**Appendix A – Technical Memorandum No. 1 - Preliminary  
Data Review and Documentation of Technical Methods**

**To:** Coachella Valley Salt and Nutrient Management Plan Technical Group      **Date:** October 16, 2014  
**From:** MWH      **Reference:** 10505158  
**Subject:** Technical Memorandum No.1 Preliminary Data Review and Documentation of Technical Methods

*A draft of this TM-1 was submitted to the stakeholders on August 29, 2014. Comments were solicited and responses to comments were documented. These are attached at the end of this TM-1 as **Addendum: Stakeholder Comments and Responses**.*

**Figure 1-4**

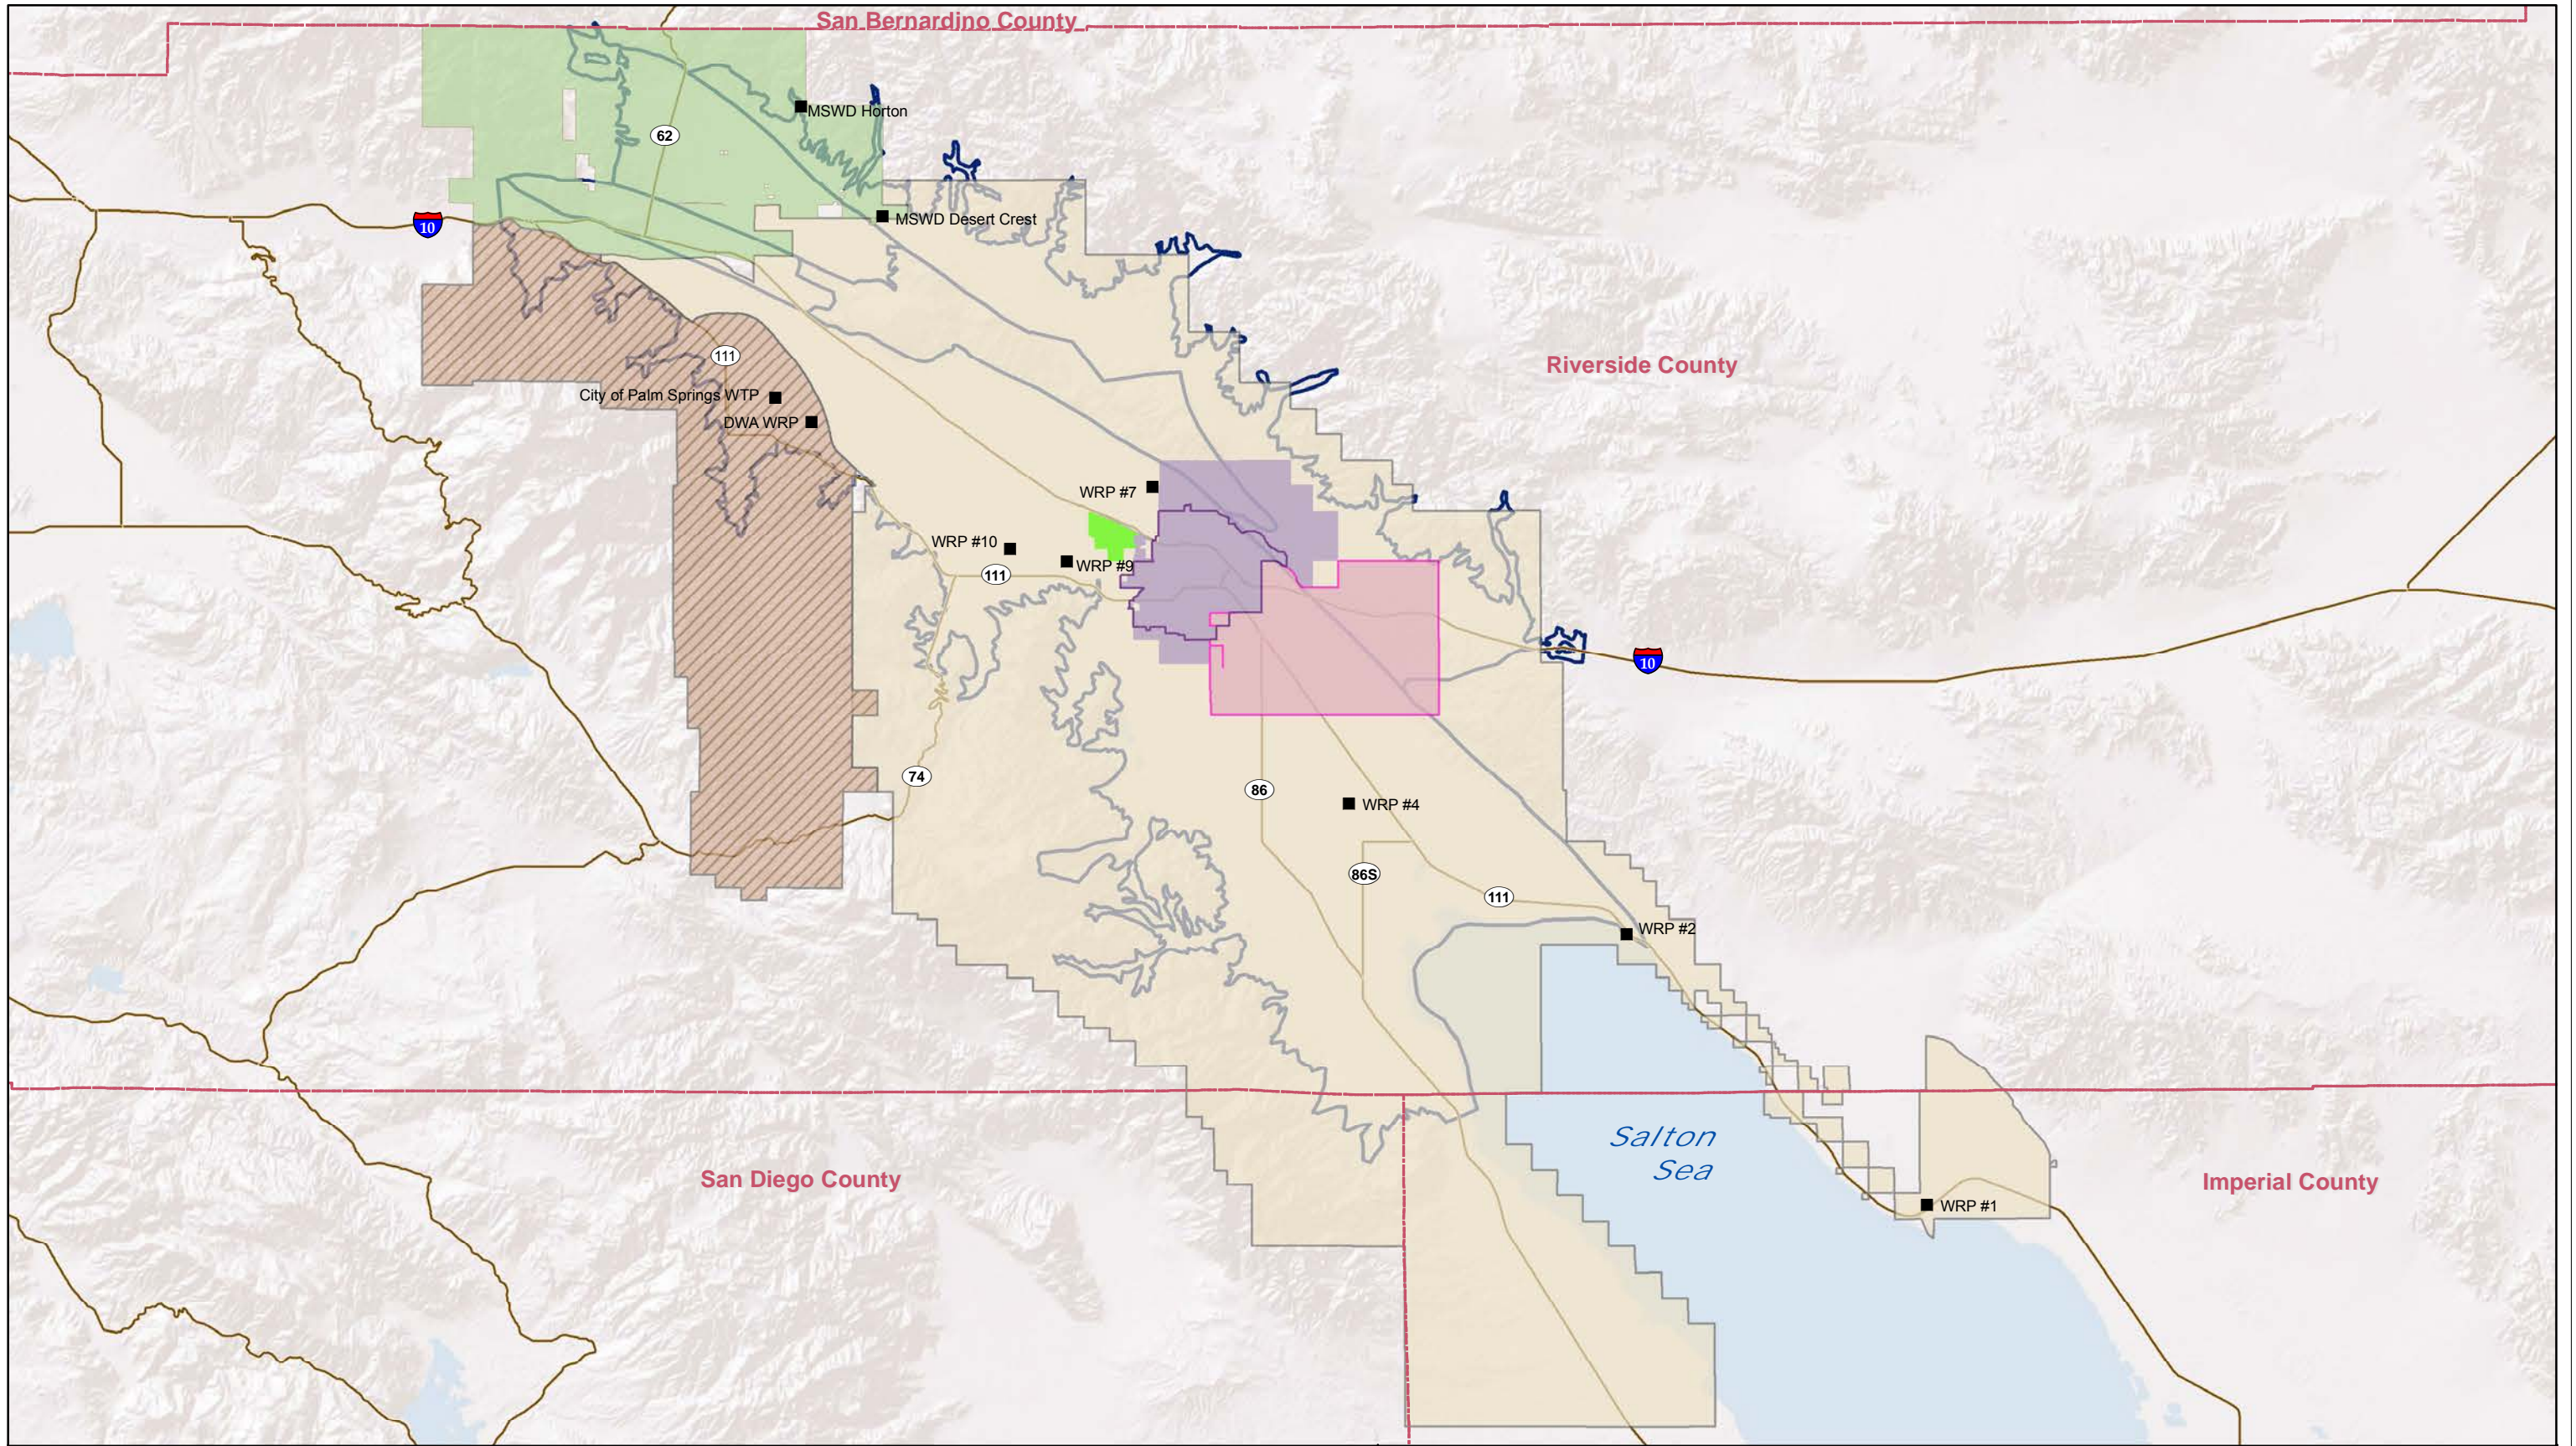
15	On page 7, Figure 1-4, IWA is not referenced in the Key to Features legend.	Commented noted, text is modified to reflect the comment.
	16	On page 9, the last sentence is incomplete.	Commented noted, text is modified to reflect the comment.
	17	On Page 10, Section 2.1, the sentence that reads "In an effort ... " the word "it" appears to be missing between the words "updated" and "in."	Commented noted, text is modified to reflect the comment.
	18	On Page 15, Section 2.3.1, the sentence that reads "For example ... " the word "as" appears to be missing between the words "such" and "contact."	Commented noted, text is modified to reflect the comment.
	19	On page 20, Section 3.1, the sentence that begins "Geologic faults" appears to be missing words in the final phrase or the word "and" should be deleted.	Commented noted, text is modified to reflect the comment.
	20	On page 20, is there no groundwater discharge to rivers or streams?	Within the study area, there is groundwater outflow to phreatophytes in southern portions of the Mission Creek Management Zone, this may have historically included discharge to streams. Currently there is only outflow to phreatophytes, tile drains, the CVSC, and the Salton Sea.

**Figure 5-2**

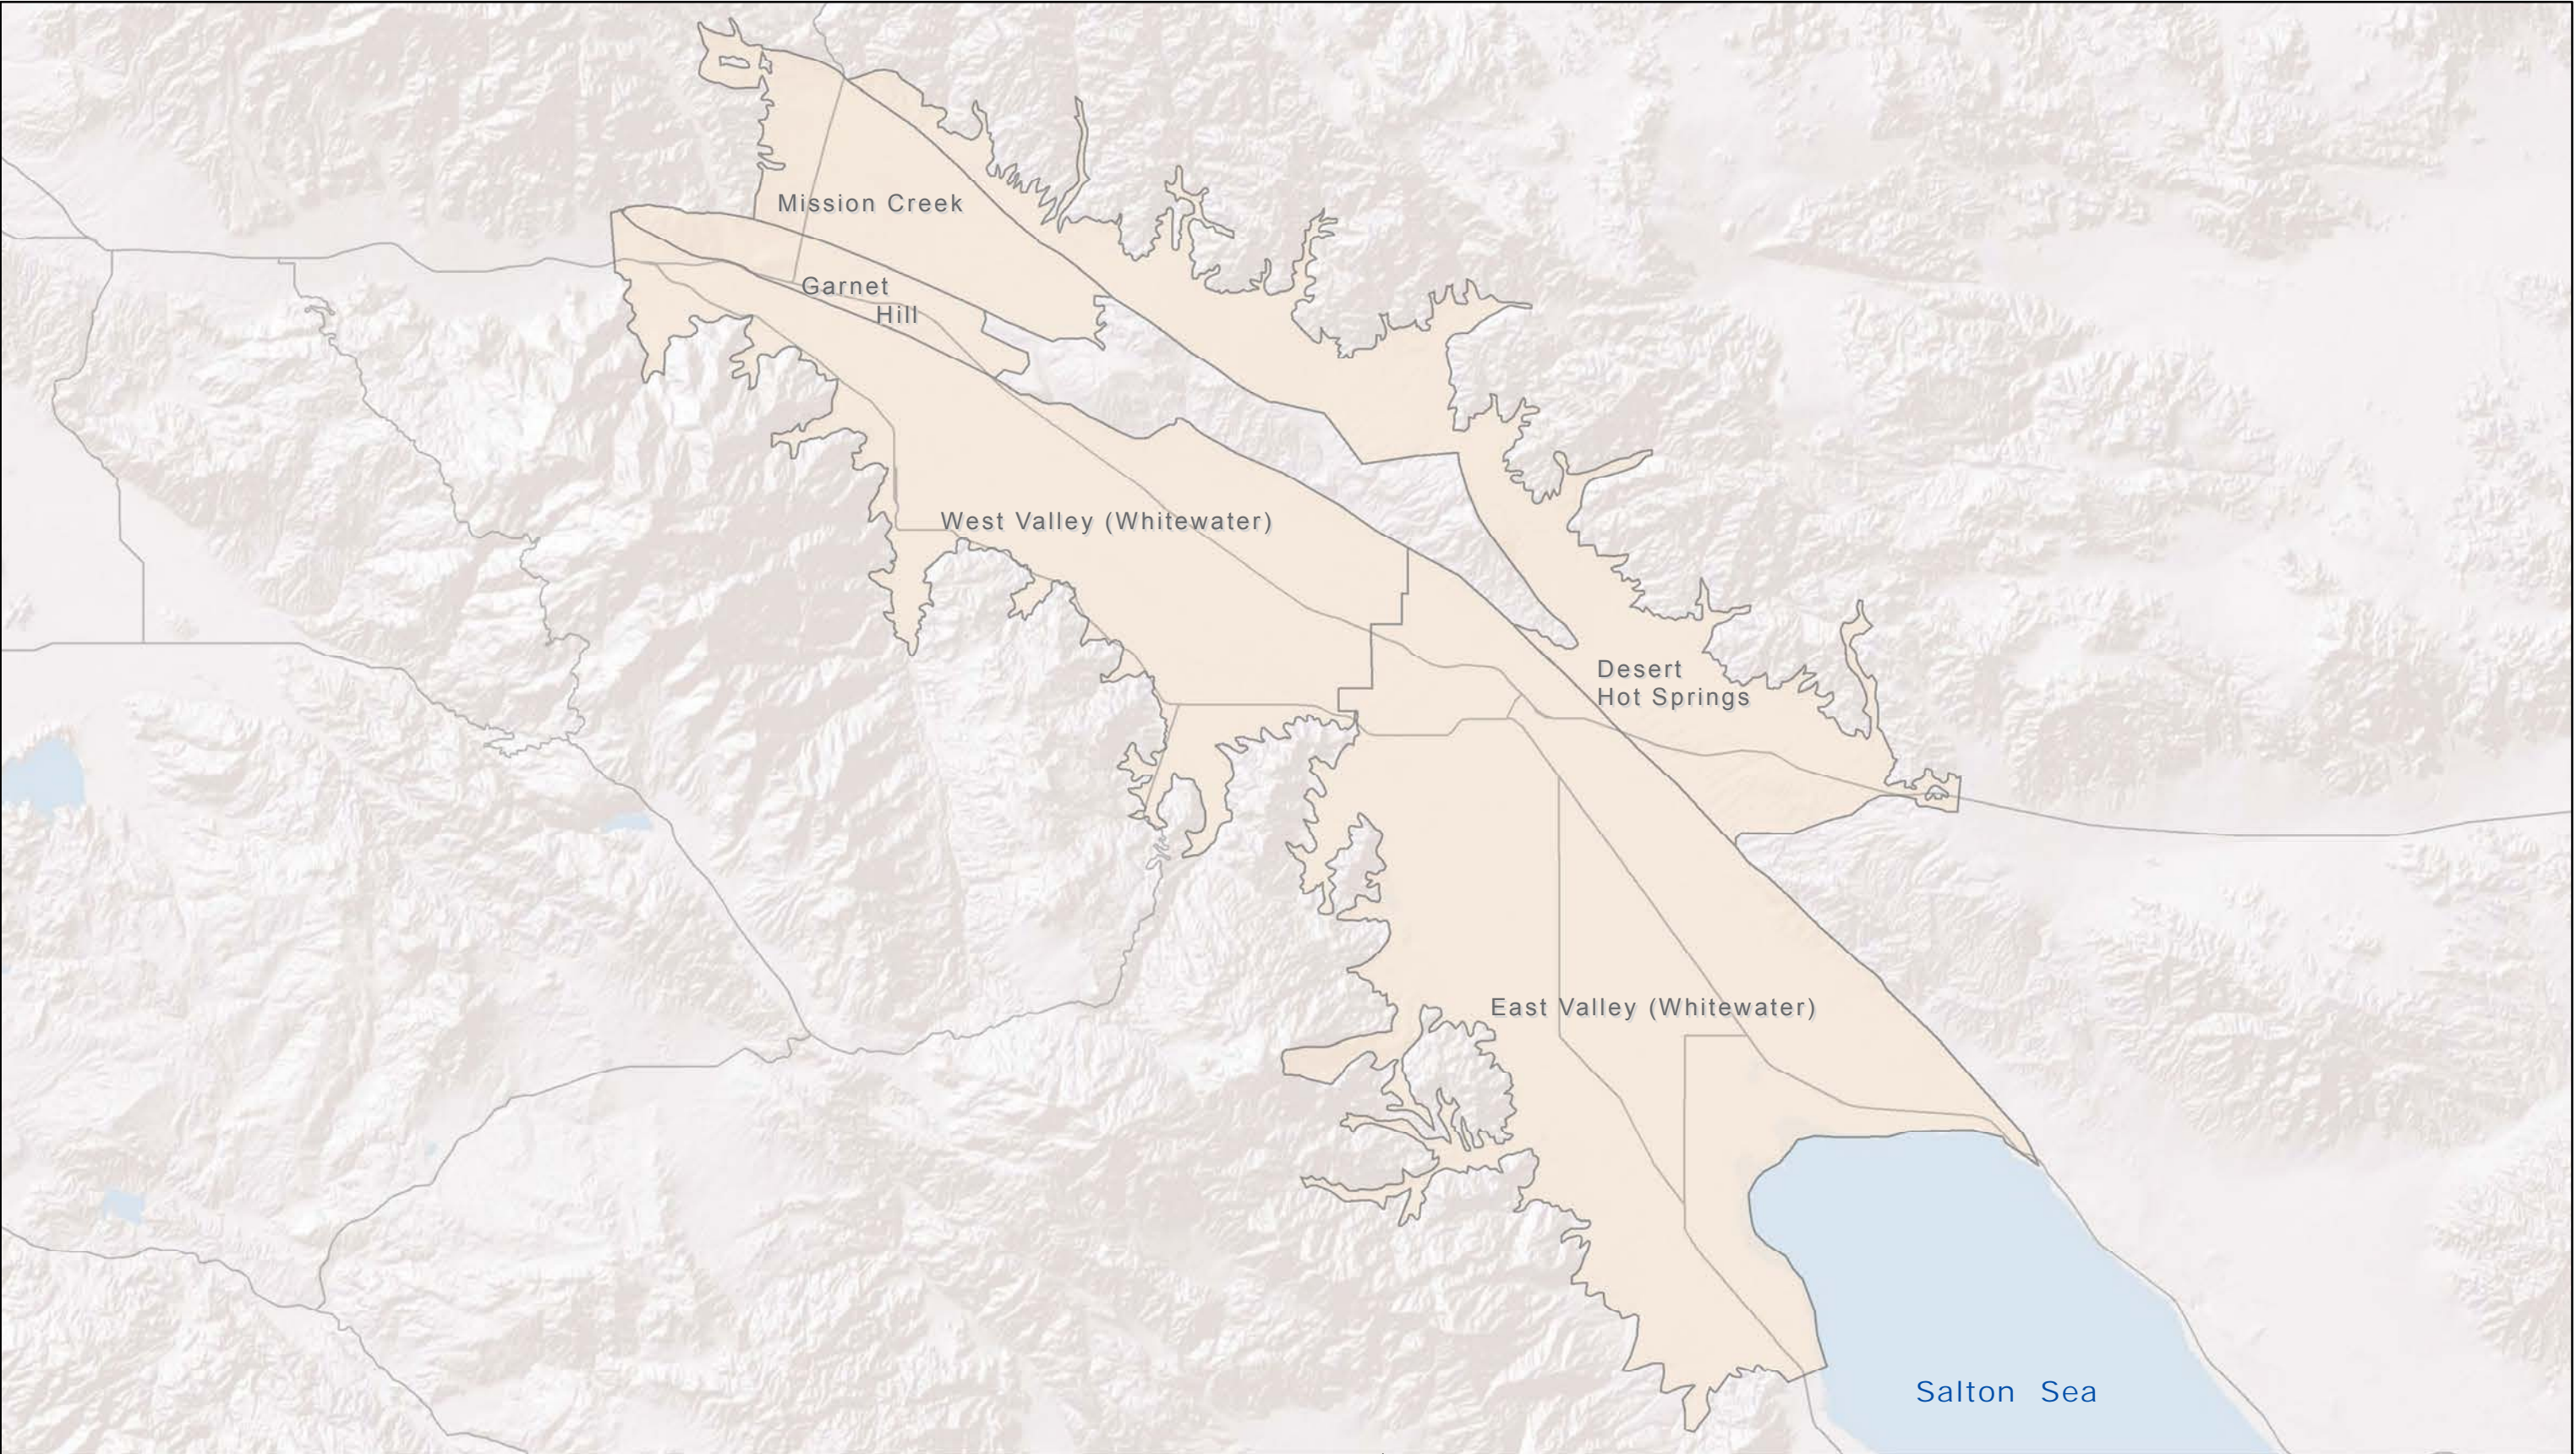
34	On page 45, Section 4.2: use of i.e. should be replaced with e.g.	Comment noted.
	35	On page 59, Figure 5-2: the legend shows a symbol for highways but none are shown in the figure.	Commented noted, the figure is modified to reflect the comment.
Bureau of Indian Affairs  Robert Eben Superintendent	36	The dominant form of groundwater chemistry should be included within the anticipated baseline data. Changing groundwater chemistry, regardless of total salt load can impact the beneficial uses of groundwater. For example a change to more sodium-based waters may cause issues related to sodic soils or worst case saline-sodic soils, if groundwater sources are to be used for irrigation within agriculture or turf grass applications such as golf courses or recreational fields.	Comment noted. Evaluating the differing forms of salts is a rigorous analysis that is out of the scope for the SNMP and not feasible. TDS, however, is a commonly used surrogate for salts and other potential constituents of concern. TDS measurements are also readily available. Use of surrogates is a common practice, for example, drinking water surrogate testing for total coliform bacteria is commonly conducted as it would be infeasible to assess water sources for each individual pathogen.
